Access Compliance Report

Public Rights-of-Way

Intersection ID: 13098	Main Street: S_CHURCH_ST	Cross Street: LINCOLN_ST	Location:	N
ADA ID: BB3D72BBA92F	Ramp Type: PerpDiag	Initial Pass/Fail: Fail	Overall Compliance: No	Severity Score: 25

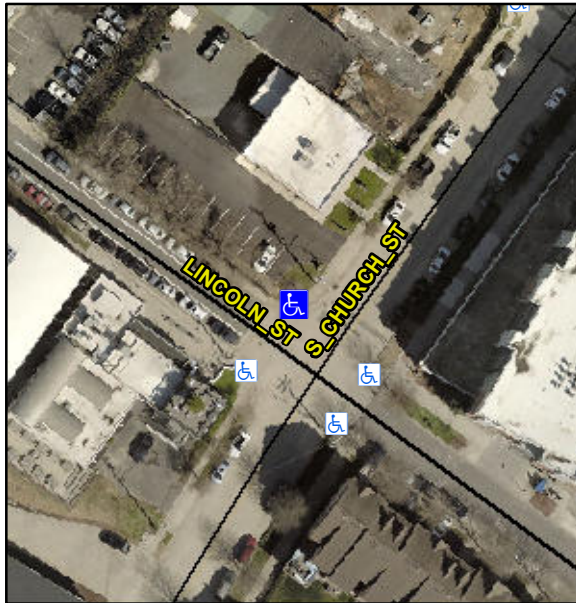
Not Found, R304.2.2, R304.5.3

Compliance	Description	Data	Compliance	Description	Data
N/A	Ramp Length (in)	78.0	No	Ramp Slope (%)	9.0
Yes	Ramp Width (in)	48.0	No	Ramp XSlope (%)	6.3
N/A	Flare Type LT	N/A	N/A	Flare Type RT	N/A
N/A	Flare Slope LT (%)	N/A	N/A	Flare Slope RT (%)	N/A
N/A	Flare Traversable LT?	N/A	N/A	Flare Traversable RT?	N/A
N/A	Landing Length (in)	N/A	N/A	DWS Provided?	N/A
N/A	Landing Width (in)	N/A	N/A	DWS Contrast?	N/A
N/A	Landing Slope (%)	N/A	N/A	DWS Length (in)	N/A
N/A	Landing X Slope (%)	N/A	N/A	DWS Full Width?	N/A
N/A	Landing Curb? (Y/N)	N/A	N/A	DWS Offset (in)	N/A
N/A	Shared Landing?	N/A			
N/A	Gutter Ponding?	N/A	N/A	Gutter Slope (%)	N/A
N/A	Gutter Lip Ht (in)	N/A	N/A	Gutter X Slope (%)	N/A
N/A	Painted X Walk1?	No	N/A	Painted X Walk2?	No
	X Walk 1 Direction	To SW		X Walk 2 Direction	To SE
N/A	X Walk 1 Width (in)	N/A	N/A	X Walk 2 Width (in)	N/A
	X Walk 1 Slope (%)	0.6		X Walk 2 Slope (%)	4.0
	X Walk 1 X Slope (%)	2.9		X Walk 2 X Slope (%)	0.2

Remove & Replace Curb Ramp With Two New Directional Ramps or Equivalent.
